Delegated Report

Householder Planning Application

Application no:	20211403
Location:	1 Cheney's Cottages Thong Lane Shorne Gravesend
Description:	Application for the approval of conditions 3, 4 and 5 attached to planning application reference number 20190929 allowed on appeal under reference number APP/K2230/D/20/3244216 relating to (3) external facing materials, (4) pedestrian visibility splays and (5) soft landscaping.
Applicant:	Mr & Mrs D Chubb
Site Visit Date:	N/A

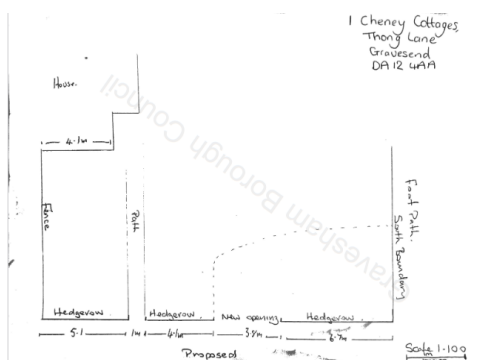
In terms of the materials I have serious concerns as it is possible for gravel etc. to be dragged onto the highway resulting in a safety hazard, with stones being thrown into the air by passing traffic. (Sections 148 and 149 of the Highways Act 1980, <https://www.legislation.gov.uk/ukpga/1980/66/part/IX/crossheading/obstruction-of-highways-and-streets>) It is for this reason that KCC as Highway Authority request that the first 6 metres of any drive is constructed in a bound material.

As presented I would therefore suggest that the proposed materials are not acceptable.

I have no objections to this proposal for the surfacing, providing it is installed in accordance with the manufacturer's specification's.

Current plan

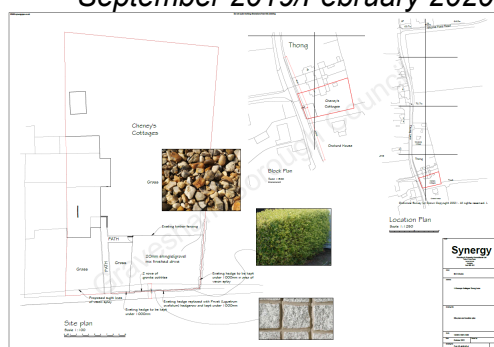
The Parish Council notes that the plan submitted with this application differs from the sketch previously submitted for the September 2019 planning application ref 20190929, and the subsequent successful Appeal submitted in February 2020, as the parking area is twice as large and the path has been extended sideways:

Condition 3 (External facing materials including paths etc): The planning statement refers to gravel being laid on existing concrete/hard surface. This would be true for the path from the road to the front door, which seems to have been laid between May 2018 and April 2019. The plans now submitted show another path element being newly proposed, leading to and from the parking area.

The parking area was previously grass and a (removed) hedge. Builders rubble appears to have been deposited on the grass. This area is now to be gravelled which will create a large bare area twice as large as previously indicated and permitted, the proposed parking area now being approximately 12m wide by 9.2m deep. This may be overlarge.

The plans refer to “existing timber fencing” but this appears to be newly installed. The parking area is fully fenced off from the garden so we suggest possible Conditions that the parking area is only ancillary to the house and cannot be leased out or used to operate a business.

It is noted that no vehicle gates are shown, addition of these would require planning permission.

As originally submitted the proposed plan showed a larger hardstanding area than had been approved. A revised plan has now been received showing the hardstanding to be the size as per the approval.
